AGENDA

PARK CITY MUNICIPAL CORPORATION
HISTORIC PRESERVATION BOARD
MINUTES OF DECEMBER 5, 2012

Marsac Affordable Housing Subdivision
Units 1-10 Silver Hills Court

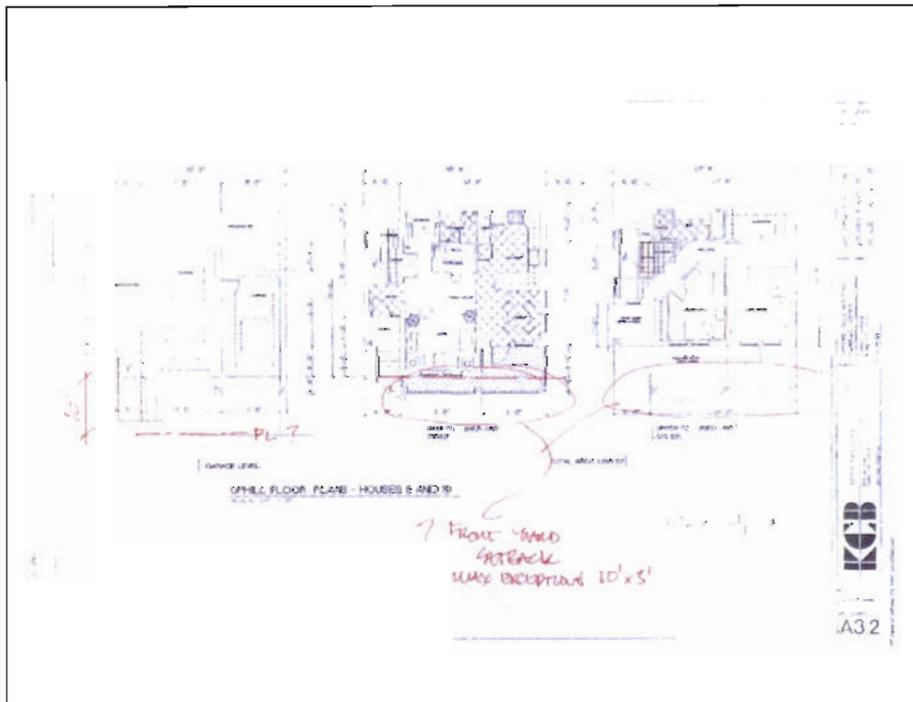
Retaining wall to rear of uphill units illustrated at 4' tall during Steep Slope CUP.
Walls 10' high are not allowed under zoning regulations. They cannot be approved during
historic district design review. See LMC 15-4-2 for separate permit process.

(Incorrect labeling North South and "Horizontal" siding)
"synthetic sidings will not be approved" 1983 Guidelines

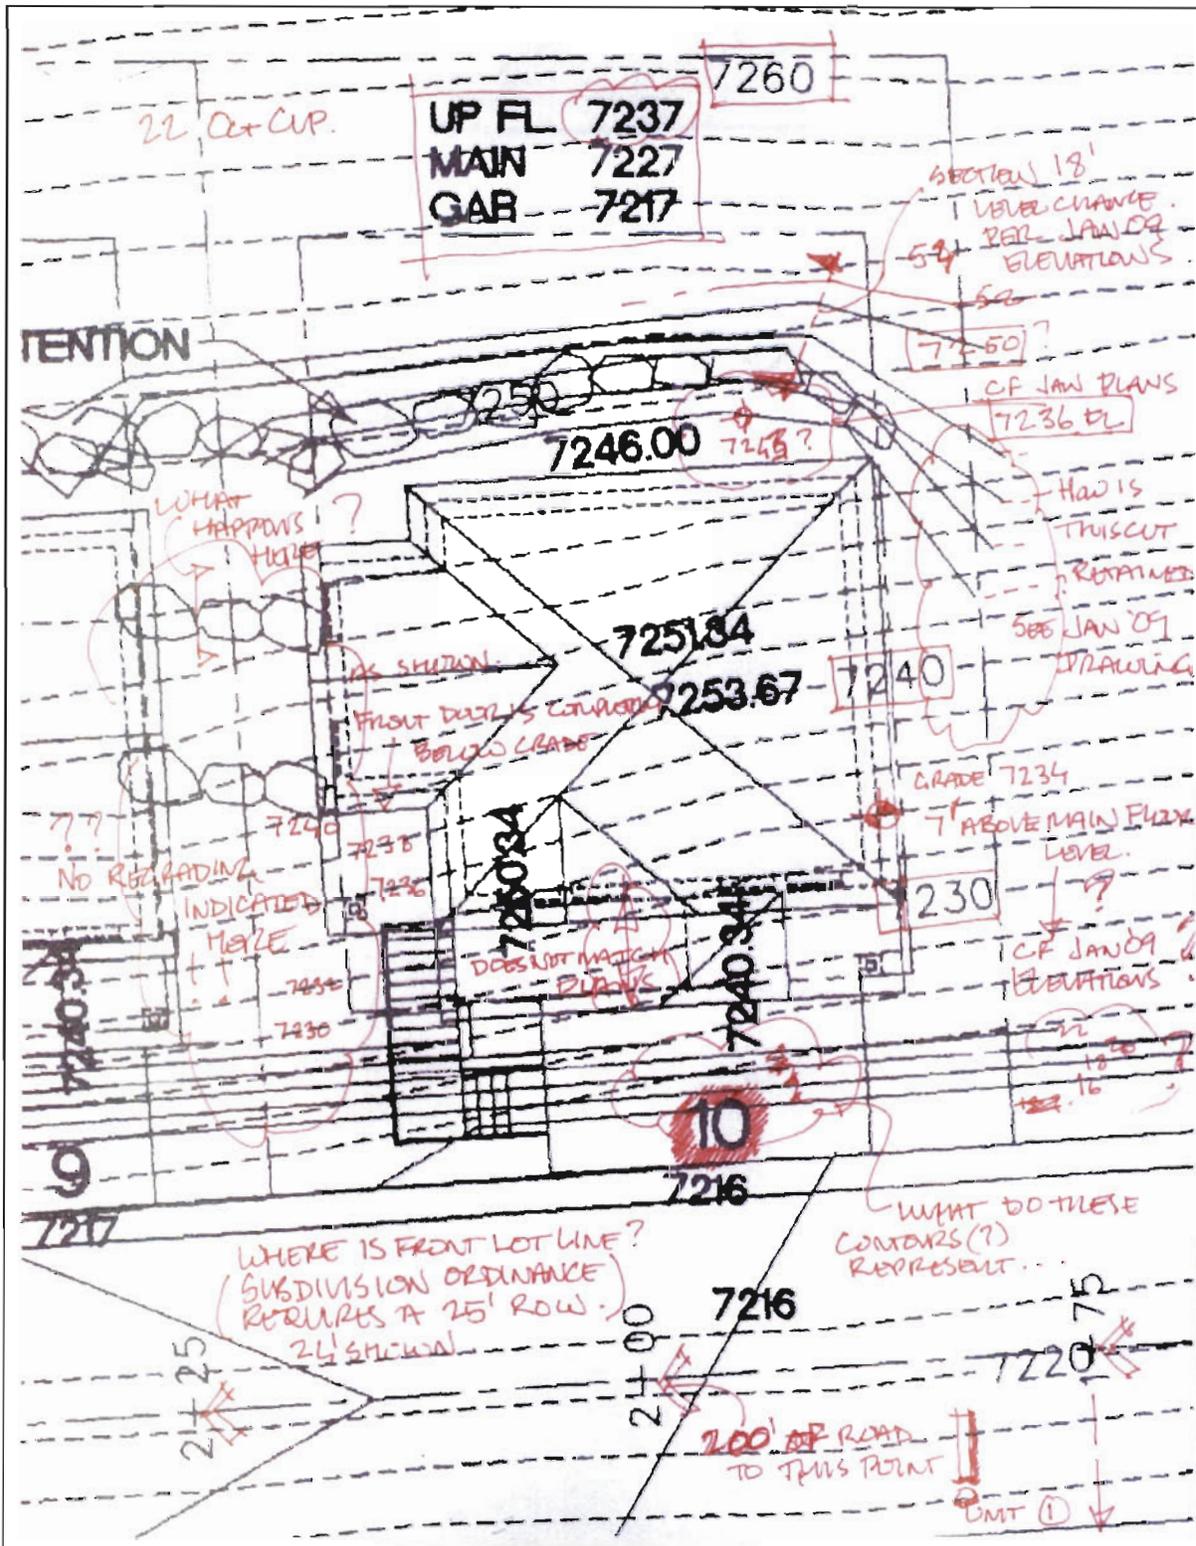
LMC HR-1 zoning regulations require a minimum 10' additional setback to third story
Carports not allowed under current design guidelines for Historic District

Just what is that 27' height line, why is it identical to North elevations units 7, 8, 10?

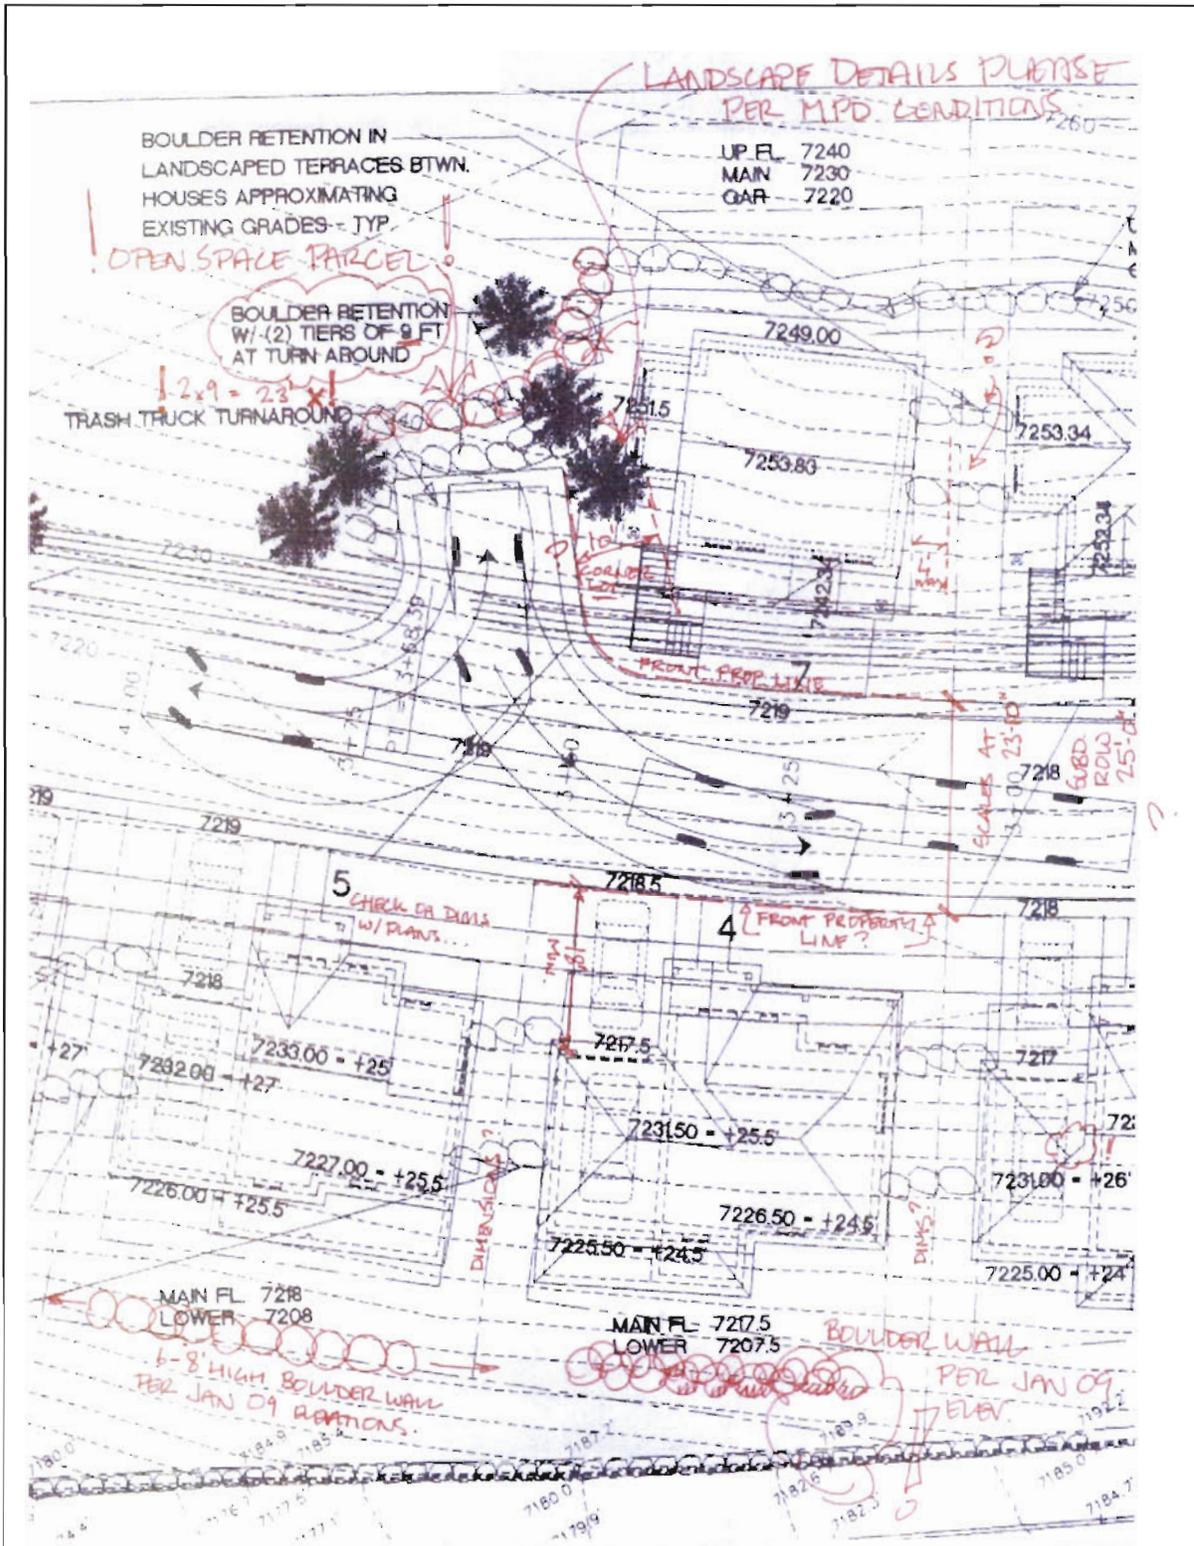
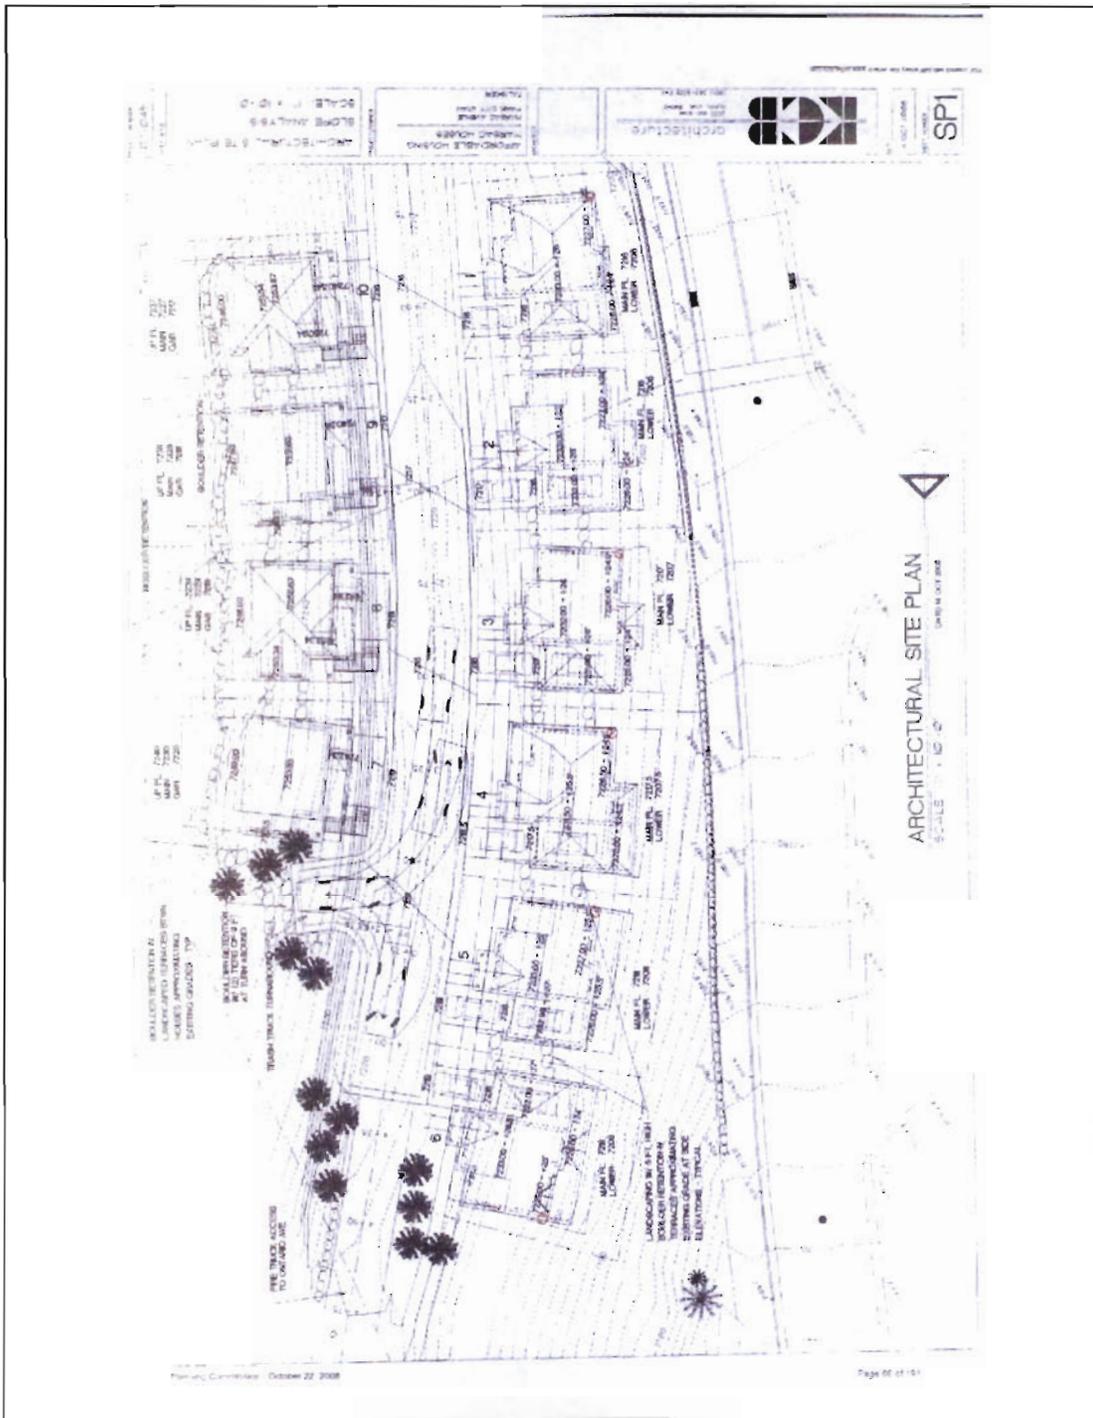
Front yard setback encroachment in breach of LMC HR=1 zoning regulations

“At the time of the Steep Slope Conditional Use Permit and the Historic District Design Review, detailed landscape plans are required. This requirement is memorialized in a condition of approval” Staff Report to Planning Commission, Master Planned Development Approval July 9, 2008 Brooks T. Robinson,

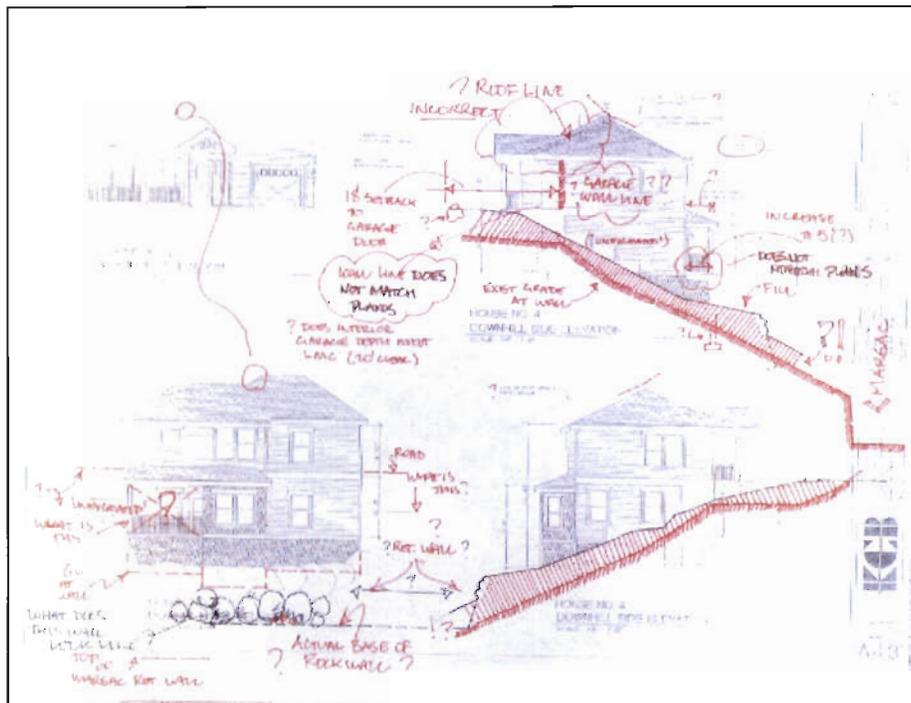
Setbacks cannot be confirmed, property lines are not shown on the elevations
Garage wall appears to have moved several feet towards edge of ROW, location and elevation of which is inconsistent with the site plan and makes the tandem outside space non conforming

LMC allows a maximum grade change of four feet within the HR-1
Lack of site information and inconsistency within elevations prevents full analysis
Relationship of downhill Units with Marsac Ave should be carefully considered

Unit Seven, North. Illustrating proposed grades and retaining wall to rear CUP, HDDR

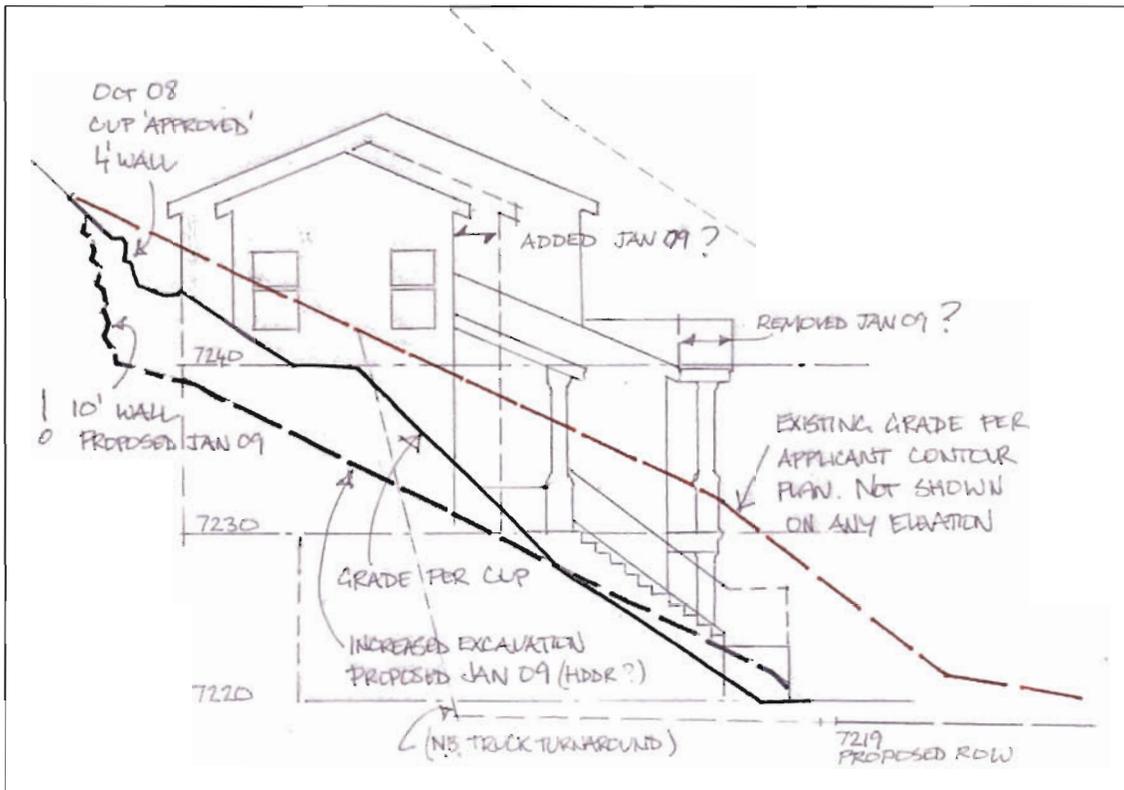
Newly proposed retaining walls, two and one half times the height previously indicated with a corresponding drastic increase in excavation and site disturbance. This proposal is in startling opposition to contemporaneous proposals to amend the LMC. Proposals which were later adopted **and backdated to Oct 2008.**

Retaining walls over six feet high cannot be granted as part of an Historic District Design Review, unless previously permitted by an MPD or Steep Slope CUP. They may be granted as a Conditional Use subject to application and noticing requirements under LMC 15-4-2. Note also, this wall is continuous across the four uphill lots and will be required to wrap around the North side of unit 7 & and the South side of unit 10. This newly proposed wall will approach two hundred feet in overall length.

August 2008 Subdivision map shown above, with proposed units below

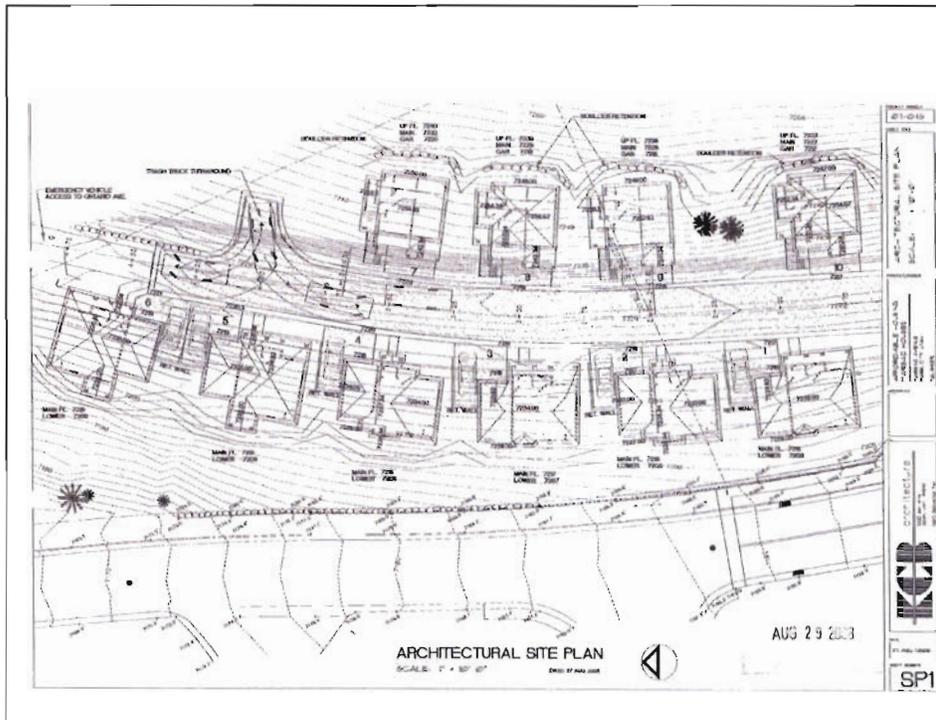
The August 2008 Subdivision layout, together with preliminary approvals granted by the Planning Commission for an associated Steep slope CUP, were rejected by the City Council in October 2008 when it was demonstrated (by the appellants to this design approval) that the proposed architectural layout and designs from Aug 2008 failed to meet LMC setback criteria (amongst others).

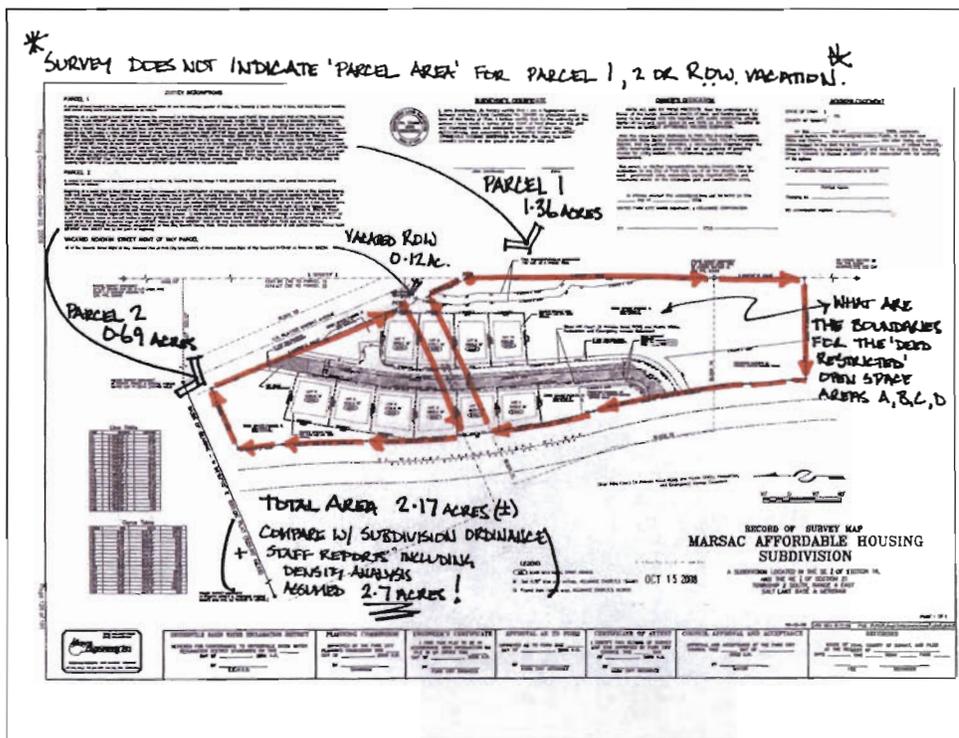
The original HDDR layout, rejected during Subdivision and Steep Slope CUP process. The revised plans Oct, 2008 and Jan, 2009 fail to resolve outstanding Subdivision issues. (Final Sub-division Oct 2008 below)

Outstanding issues on subdivision layout

SIDE ELEVATION - UPHILL UNIT - SOUTH
SCALE: 1/4" = 1'-0"

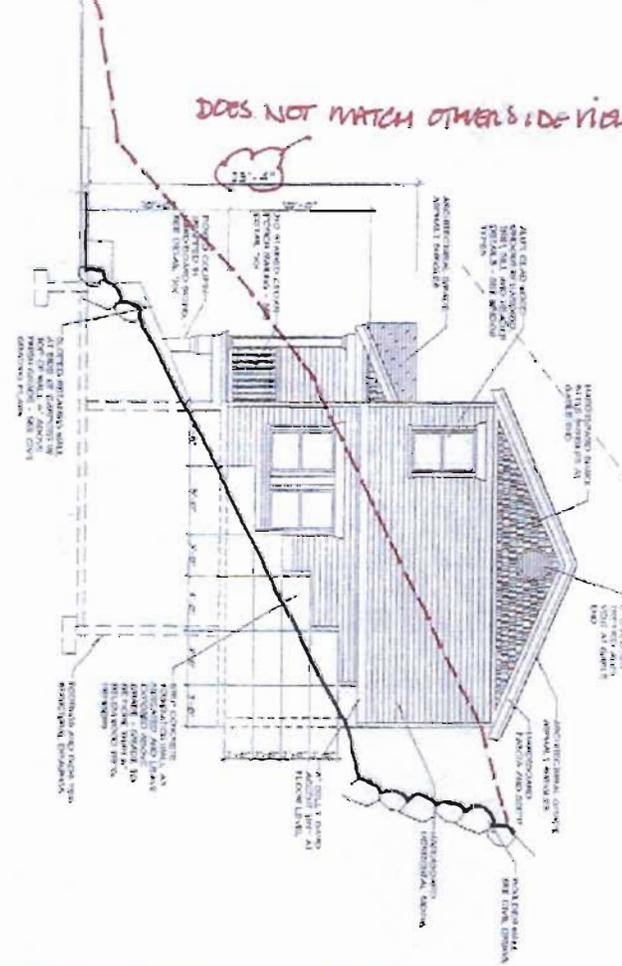
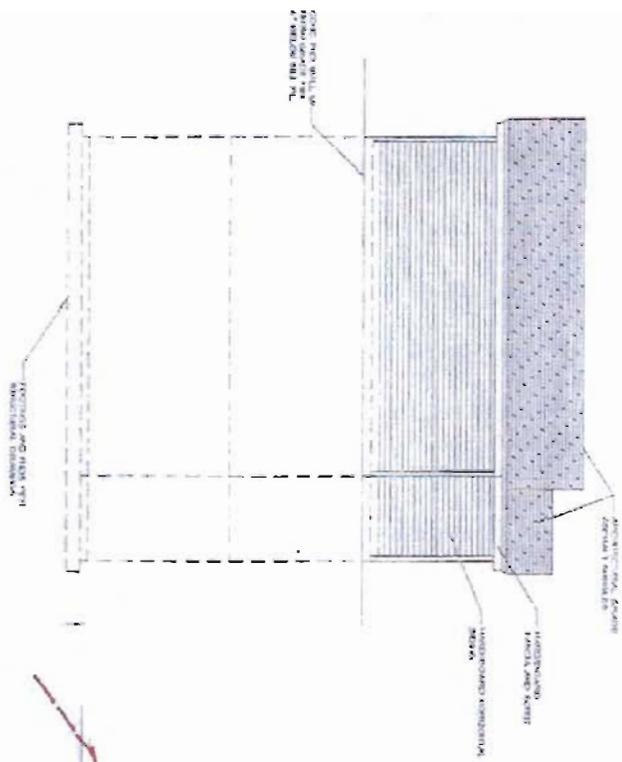
DOES NOT MATCH OTHERS IDE VIEW.
